RESOLUTION MSC.226(82)

**ADOPTION OF AMENDMENTS TO THE REVISED RECOMMENDATION
ON TESTING OF LIFE-SAVING APPLIANCES, AS AMENDED**

**AMENDMENTS TO THE REVISED RECOMMENDATION ON TESTING
OF LIFE-SAVING APPLIANCES, AS AMENDED**

Figure 4 – Stretcher dimensions (mm)

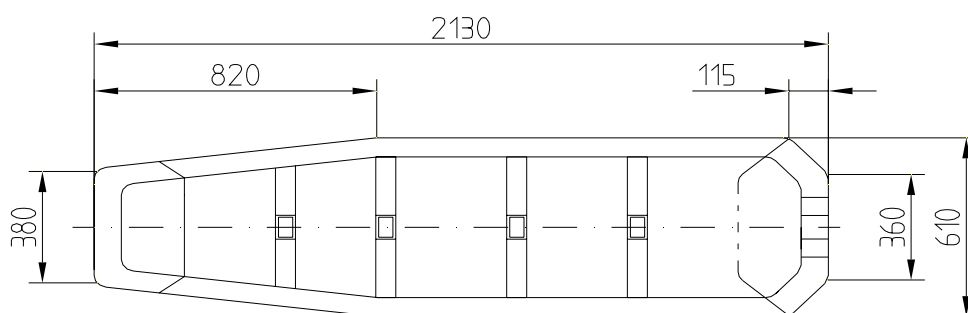
25 In paragraph 7.1.3, in the second sentence, the words “on a stretcher of similar dimensions to those shown in figure 4” are inserted between the words “lie down” and “and the others” and the following figure is inserted after the paragraph:
